**From:** Tim MAY <mayengineering@sbcglobal.net>  
**Sent:** Monday, June 19, 2023 11:27 PM  
**To:** wScheer@eltownhall.com  
**Cc:** Kristen Clarke; Paul Geraghty; Gary Goeschel  
**Subject:** Revised Drainage calculations to address Town Engineer comments - Nehantic Highlands) subdivision  
**Attachments:** Revised Nehantic Highlands Subdivision Drainage Report.docx.pdf

Please find attached the revised drainage report for Nehantic Highlands Subdivision. I have addressed the seven comments from your June 7th letter.

## DRAINAGE REPORT

Nehantic Highlands Subdivision  
Kristen Clarke P.E. & Shelly Harney.

Site Development and Stormwater  
Drainage Flow Paths

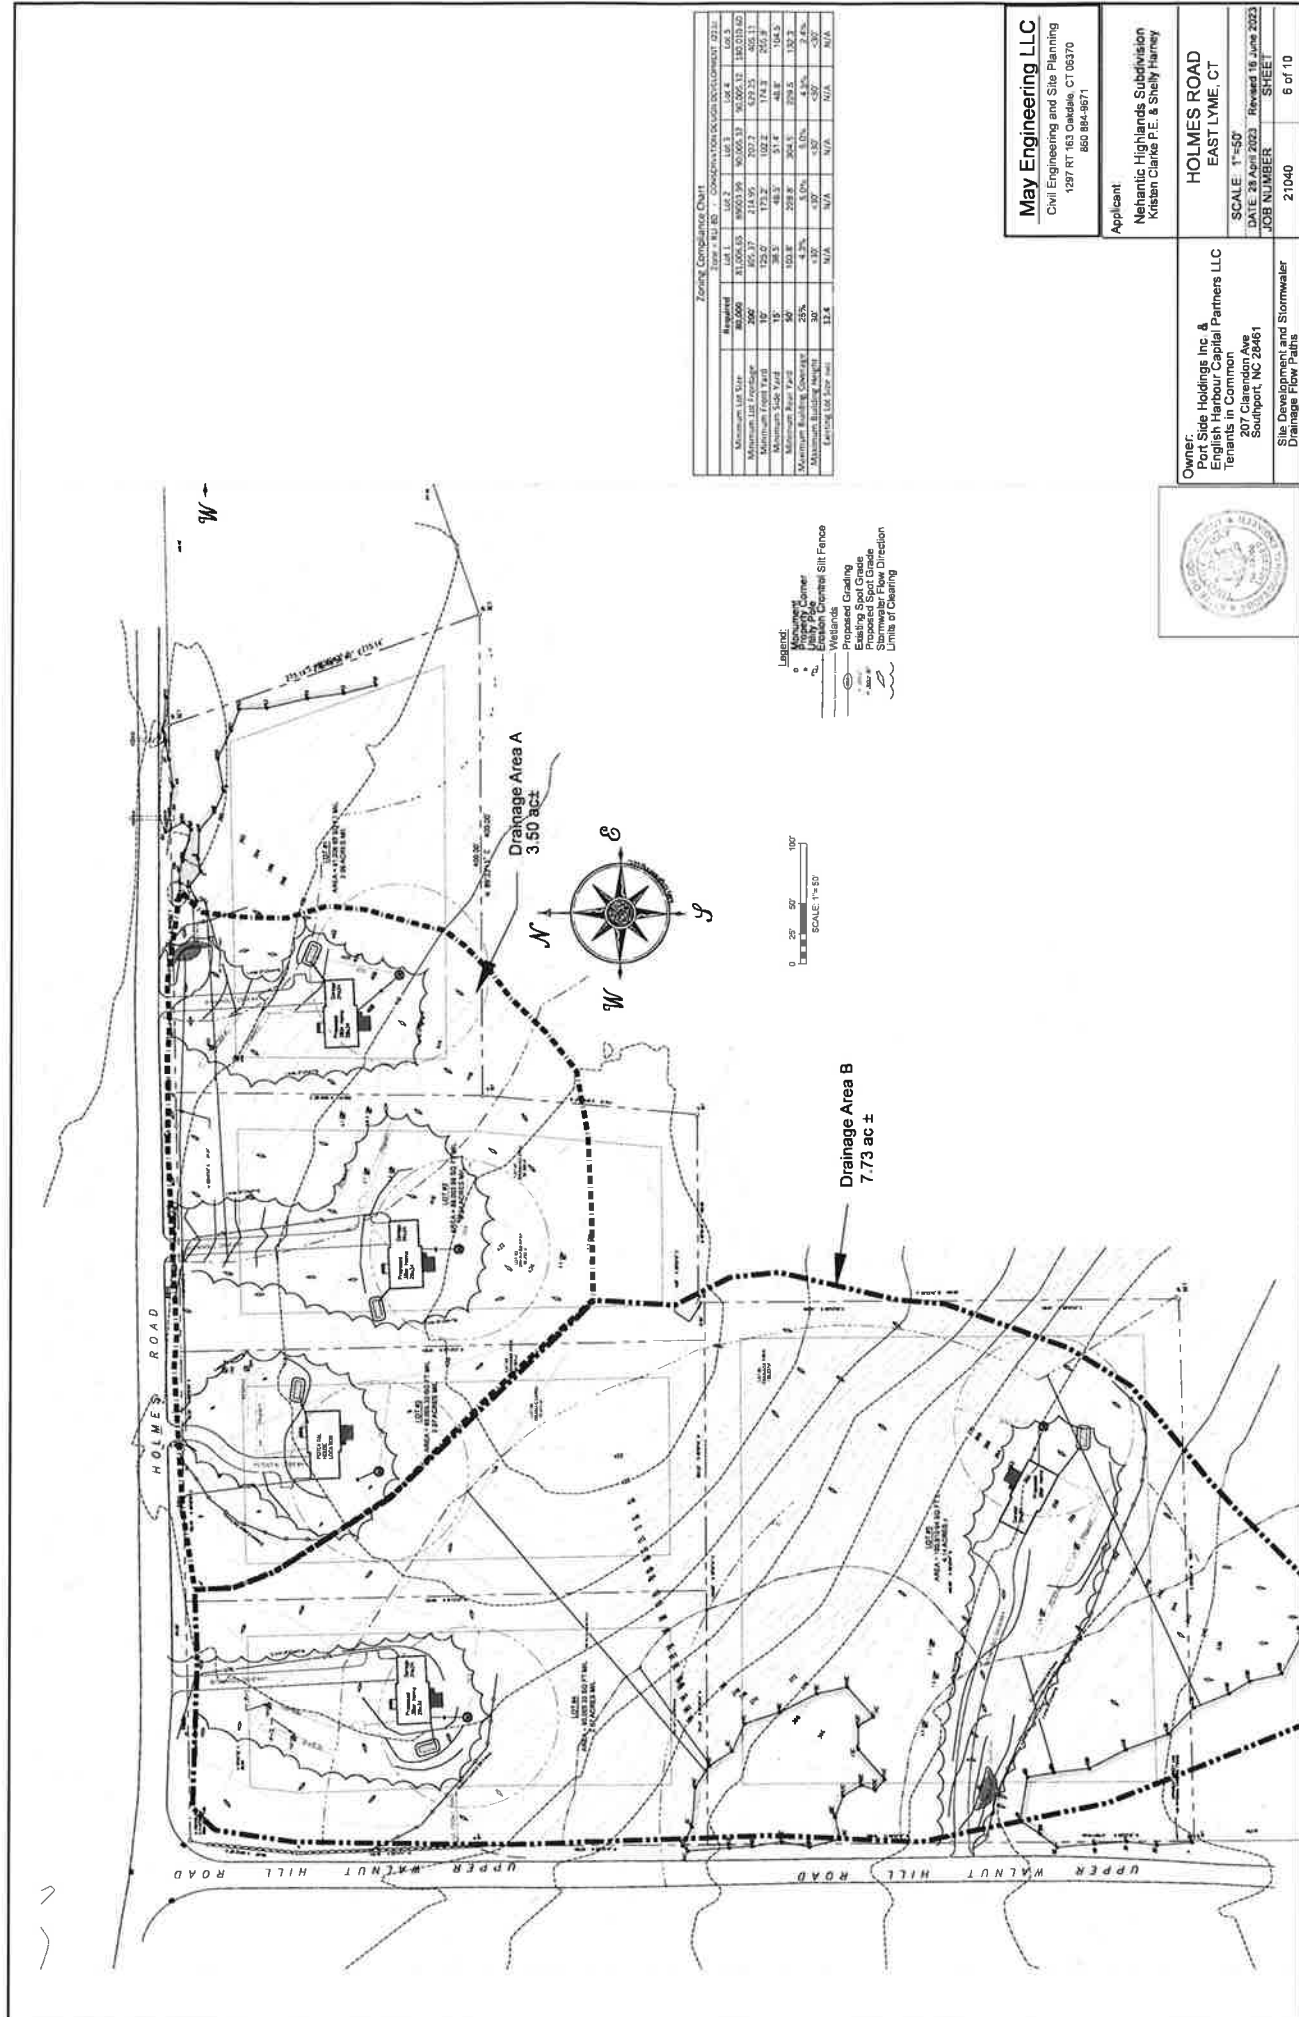
*6. Limits of disturbance should be clearly identified.*

*7. Proposed grading should be indicated through areas within the limits of disturbance.*

Limits of clearing and grading was made more visible on drainage plan (sheet 6 of 10) and is included in the appendix of this report
